End of Life Notification for PFCN0067

PCN Number	PTNTOP00670111
Publication Date	15/01/2025
Effectivity Date	Immediate
Change Summary	End of Life Notification for PFCN0067 Leadframe and Introduction of Replacement

PFCN0067 will be replaced by PFCN0111

PFCN0067

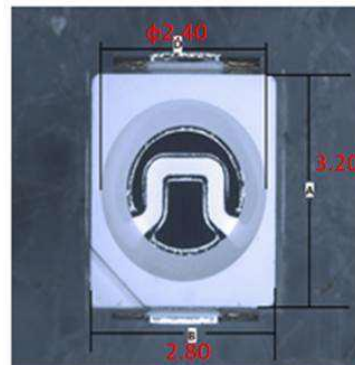
Anglia have been advised by the manufacturer Titan Opto that there is a change to the package lead frame on the part numbers listed below. There are no physical dimension changes but there are minimal die bonding and wire bonding differences as noted.

PFCN0111 is 0.06mm shorter in length, 0.2mm lower in height, 0.12mm shorter in pad width than PFCN0067.
